DN TECHNICAL COMMITTEE SUMMARY REPORT  
ICEWISE PLANK TIMELINE AND FINDINGS  
NOVEMBER 13, 2022

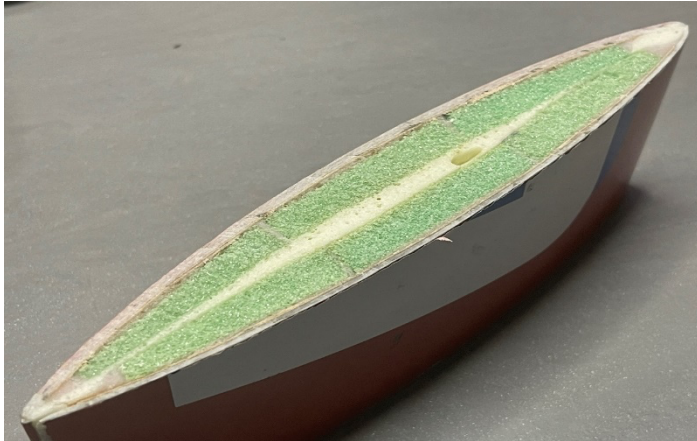
This is actual crosse section of the failed plank from the Western Championship March 2022

Picture 2

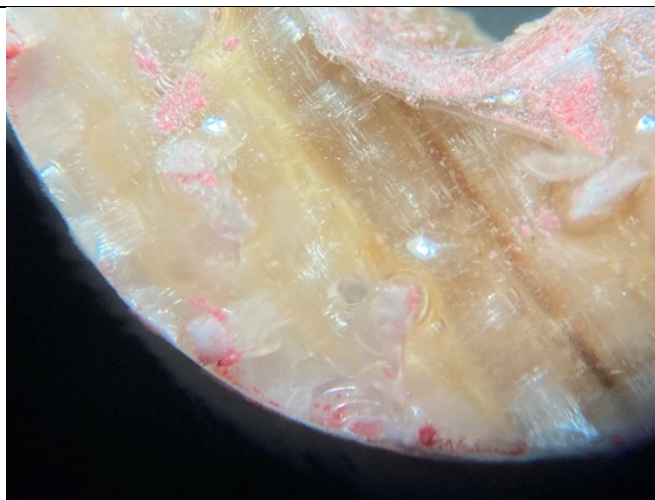
Pic 2 shows the layers. The plank is hollow where the test hole was cut. The section on the left is still glued together and consists of roughly 2mm of glass, 3.5mm of wood, and a lightweight layer of what looks like resin rich woven fiberglass. The section on the right was delaminated but similar construction.

Picture demonstrates woven fiberglass laminated to the inside of the wood on both halves. This design fails to comply to the rule: B. Runner plank interp. 11/30/98: ... *Internal fiberglass reinforcement is not allowed.*
